# CITY OF MADISON

# PLAN OF PROPOSED IMPROVEMENT

Revision 4 - 6/21/24  
Sheets U1, U2, U4

CITY PROJECT NO. 14513  
CONTRACT NO. 9277

14513	U-1
MADISON, WI	U-1
CONTRACT NO: 9277	U-1
UTILITIES PLAN & PROFILE - EAST DAYTON STREET	U-1
611 E DAYTON STREET	U-1
M:\DESIGN\Projects\14513\CAD\Sewers\14513SWR-PipeNetwork.dwg	U-1
14513	U-1
U-1	U-1

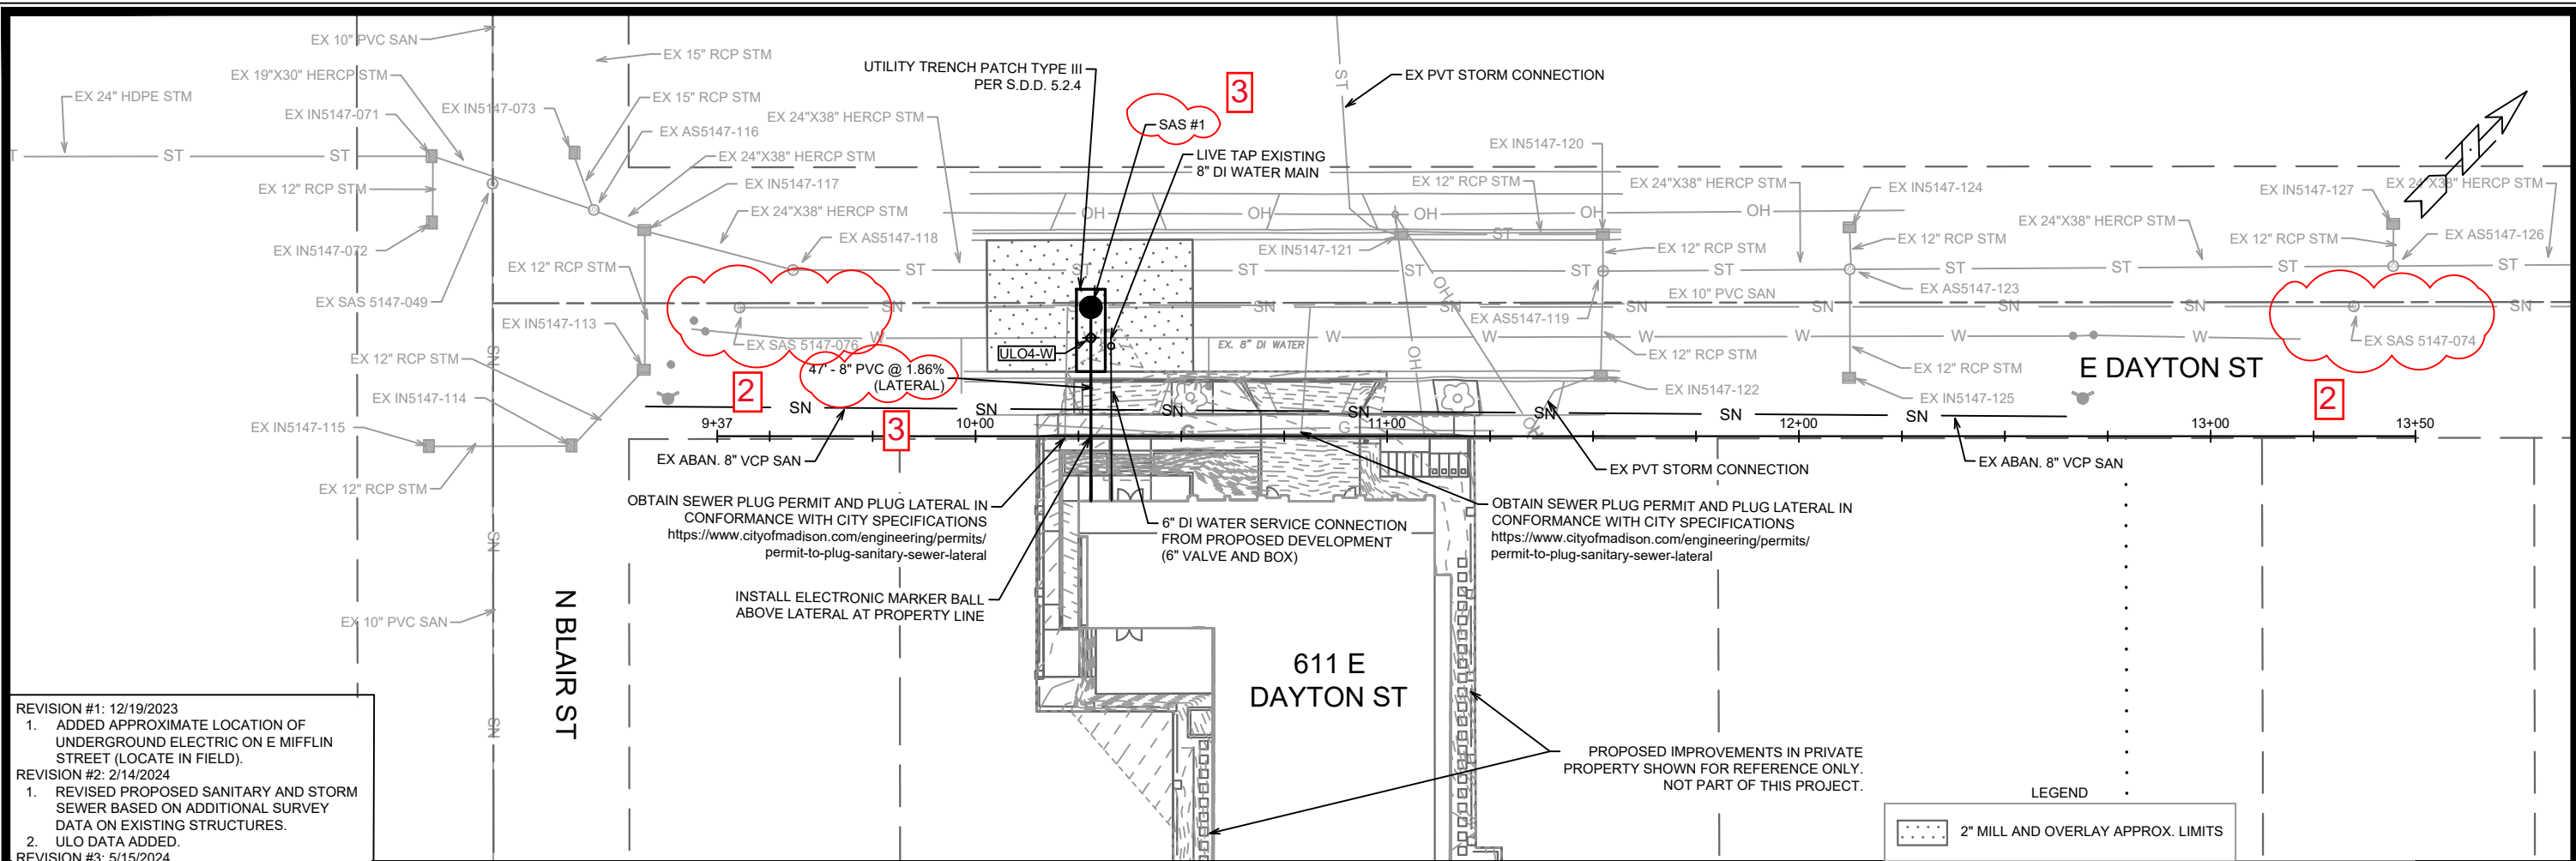
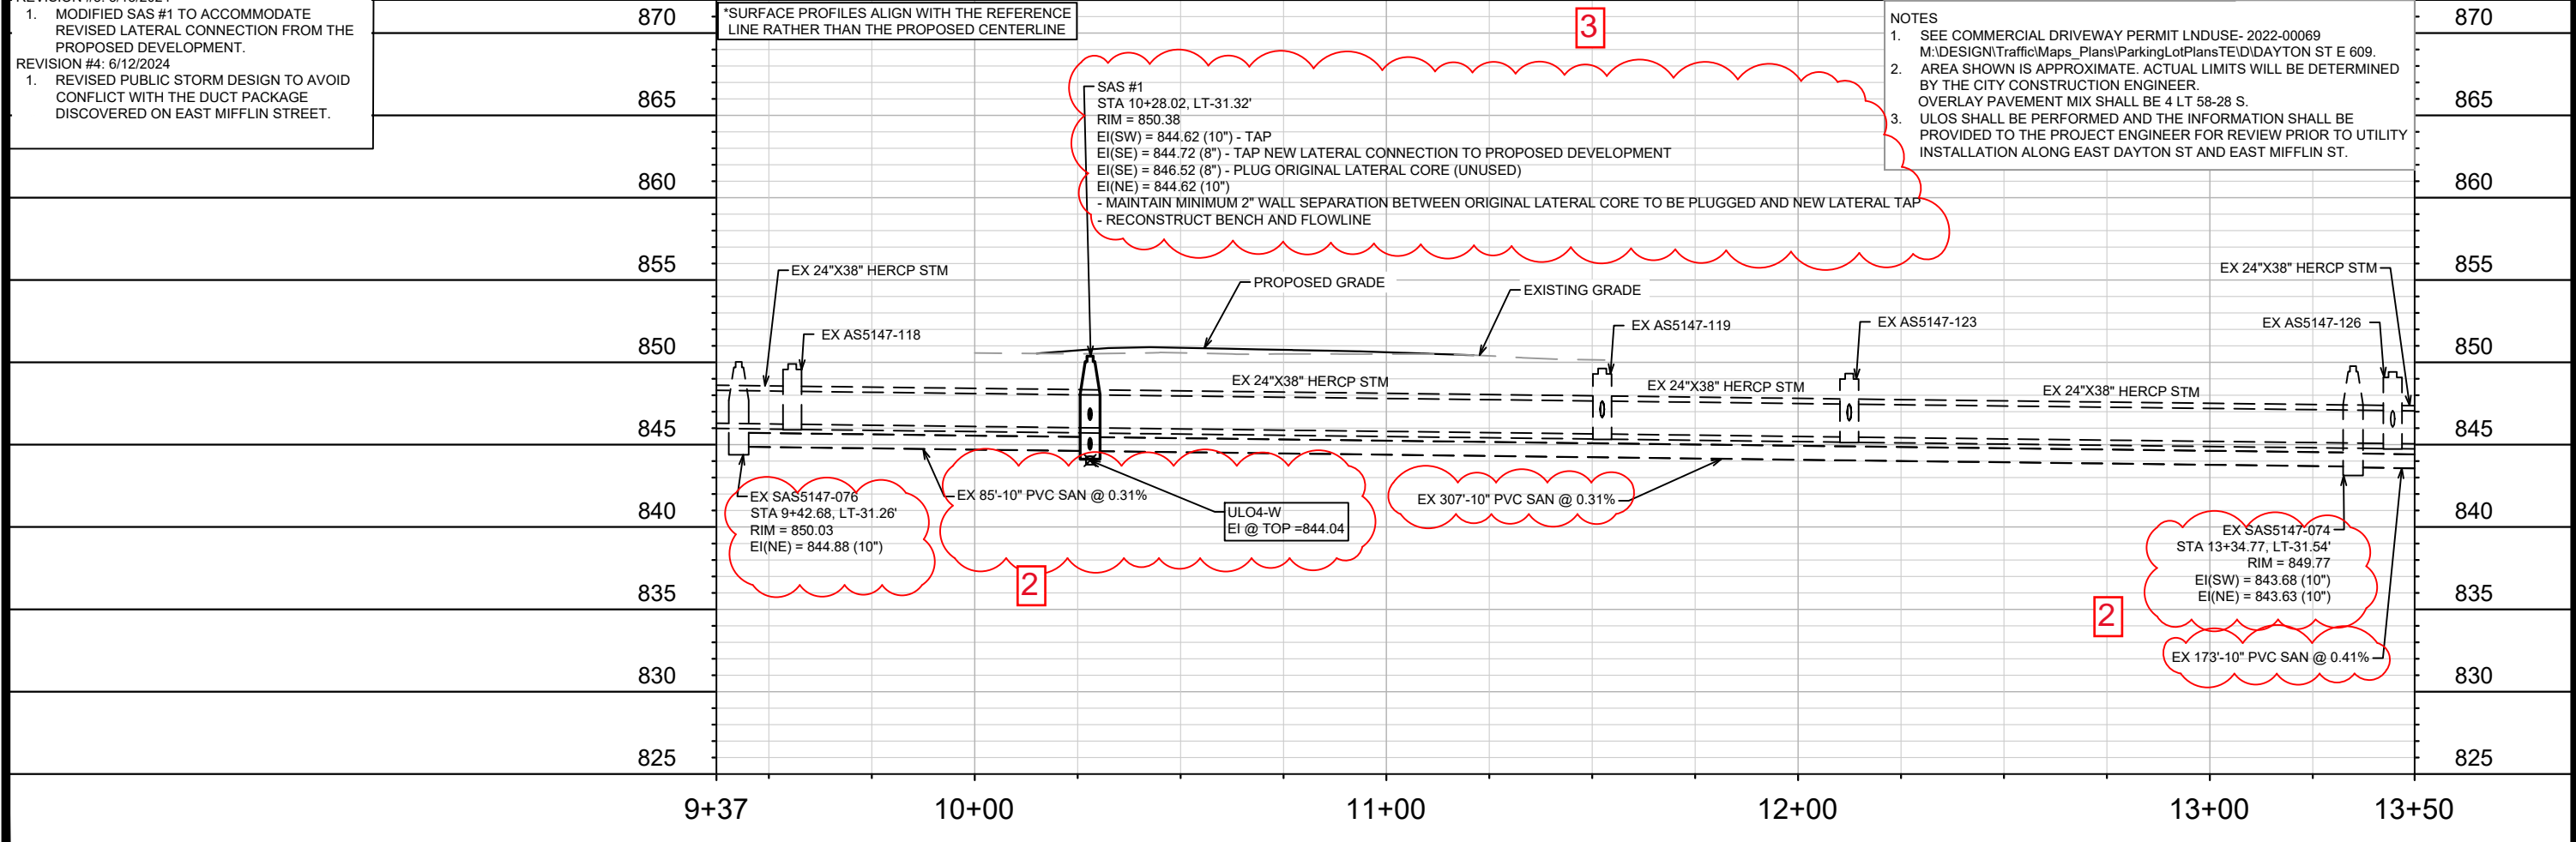
- REVISION #1: 12/19/2023  
 1. ADDED APPROXIMATE LOCATION OF UNDERGROUND ELECTRIC ON E MIFFLIN STREET (LOCATE IN FIELD).
- REVISION #2: 2/14/2024  
 1. REVISED PROPOSED SANITARY AND STORM SEWER BASED ON ADDITIONAL SURVEY DATA ON EXISTING STRUCTURES.  
 2. ULO DATA ADDED.
- REVISION #3: 5/15/2024  
 1. MODIFIED SAS #1 TO ACCOMMODATE REVISED LATERAL CONNECTION FROM THE PROPOSED DEVELOPMENT.
- REVISION #4: 6/12/2024  
 1. REVISED PUBLIC STORM DESIGN TO AVOID CONFLICT WITH THE DUCT PACKAGE DISCOVERED ON EAST MIFFLIN STREET.

UTILITIES PLAN & PROFILE - E MIFFLIN STREET  
 611 E DAYTON STREET

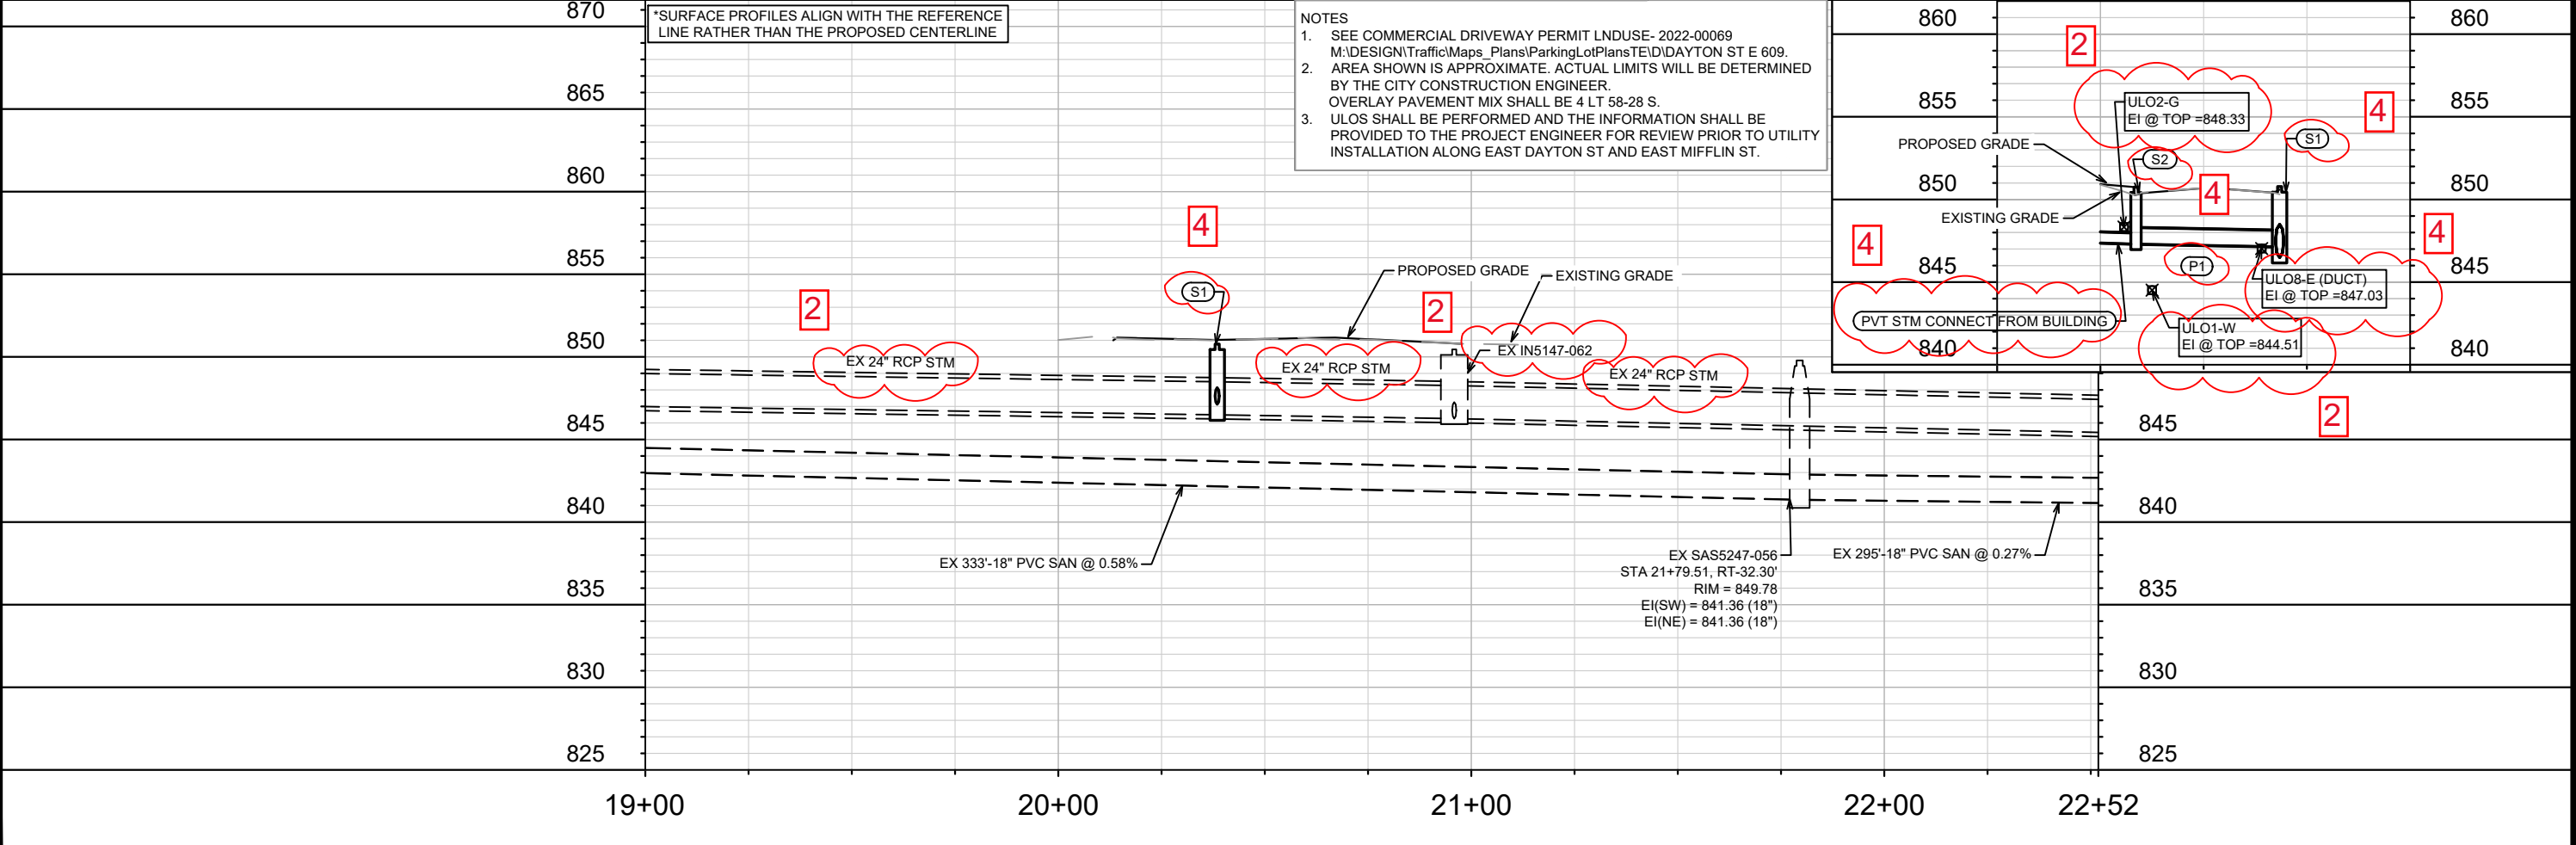
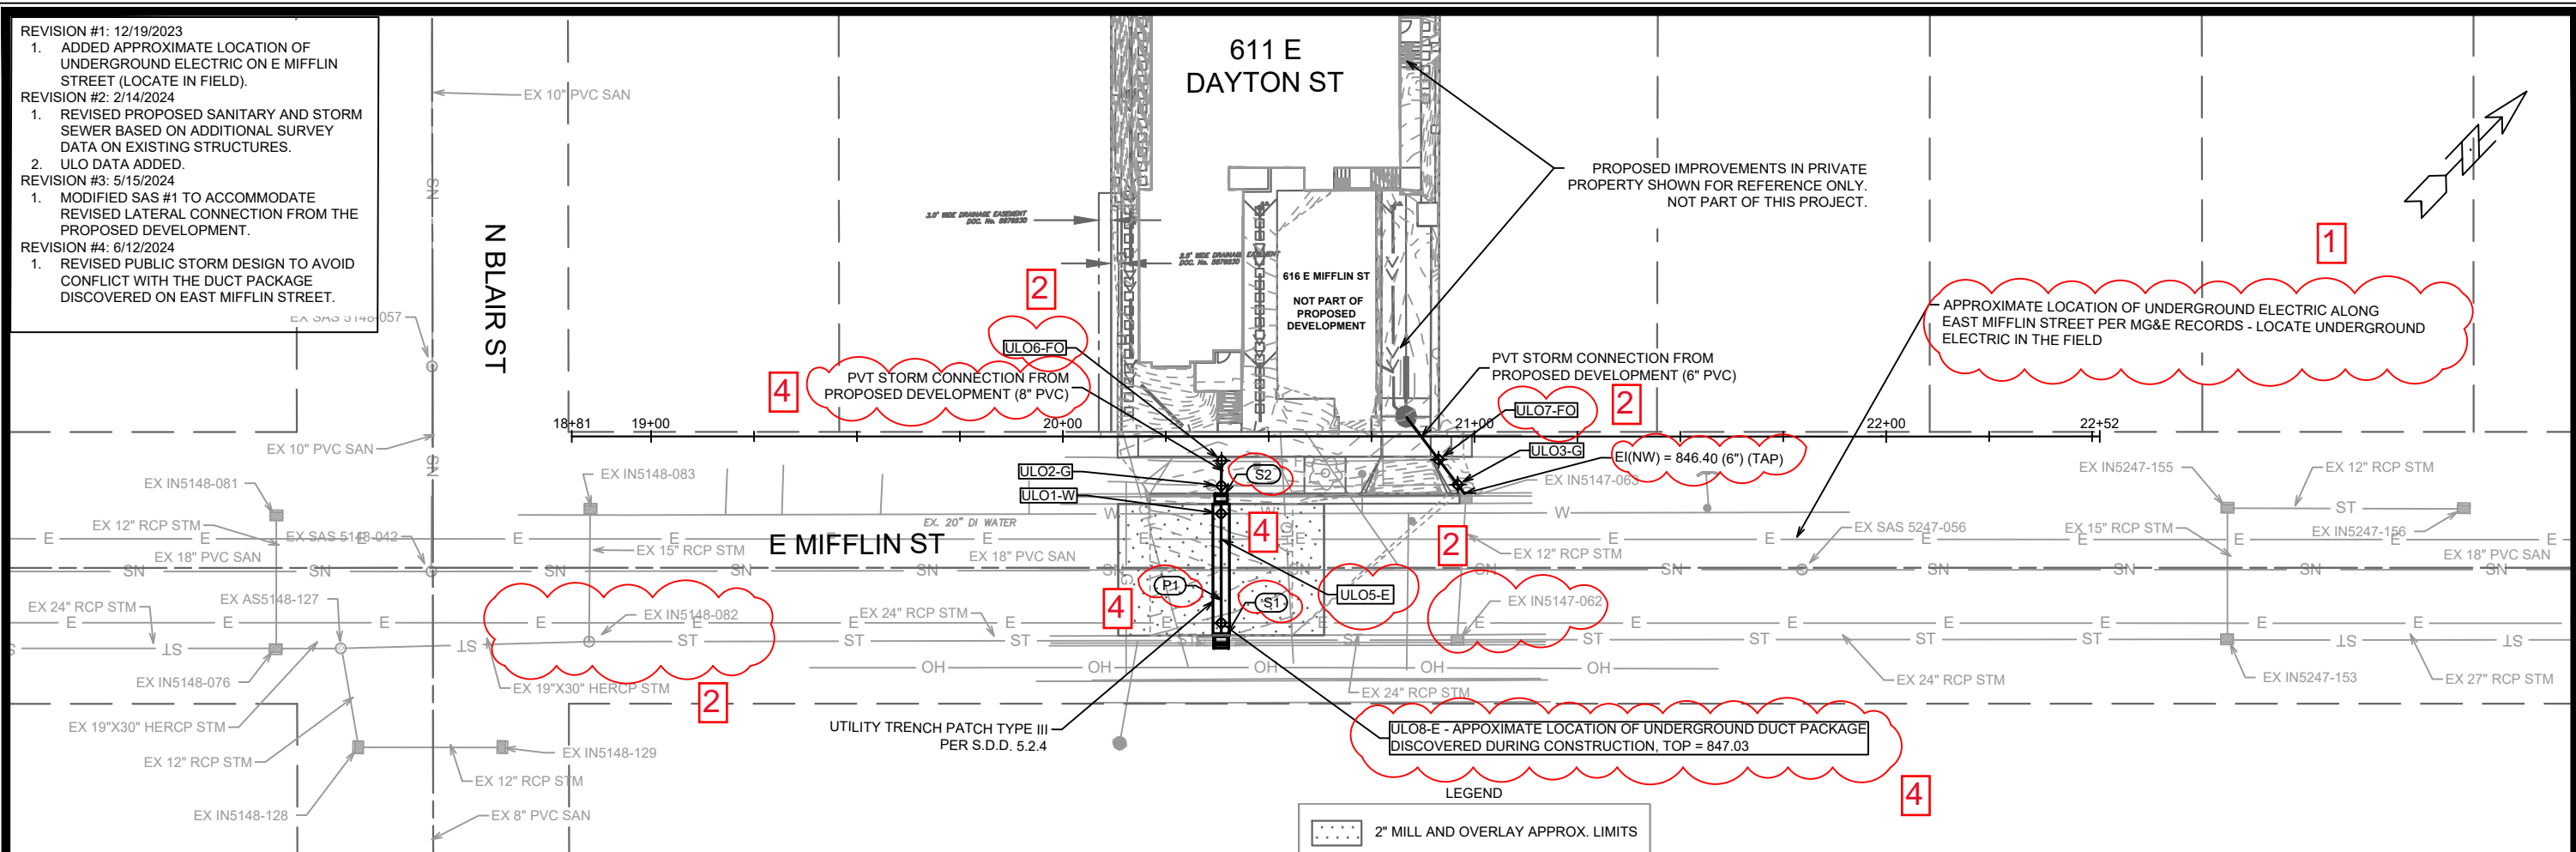
- REVISION #1: 12/19/2023  
 1. ADDED APPROXIMATE LOCATION OF UNDERGROUND ELECTRIC ON E MIFFLIN STREET (LOCATE IN FIELD).
- REVISION #2: 2/14/2024  
 1. REVISED PROPOSED SANITARY AND STORM SEWER BASED ON ADDITIONAL SURVEY DATA ON EXISTING STRUCTURES.  
 2. ULO DATA ADDED.
- REVISION #3: 5/15/2024  
 1. MODIFIED SAS #1 TO ACCOMMODATE REVISED LATERAL CONNECTION FROM THE PROPOSED DEVELOPMENT.
- REVISION #4: 6/12/2024  
 1. REVISED PUBLIC STORM DESIGN TO AVOID CONFLICT WITH THE DUCT PACKAGE DISCOVERED ON EAST MIFFLIN STREET.

NO.	REVISION	DATE	BY
4	STORM SEWER DESIGN REVISION	6/12/24	EAC
2	RIM/IN/ELEV REVISIONS & ULOS	2/14/24	EAC
1	UNDERGROUND ELECTRIC ADD	12/19/23	EAC
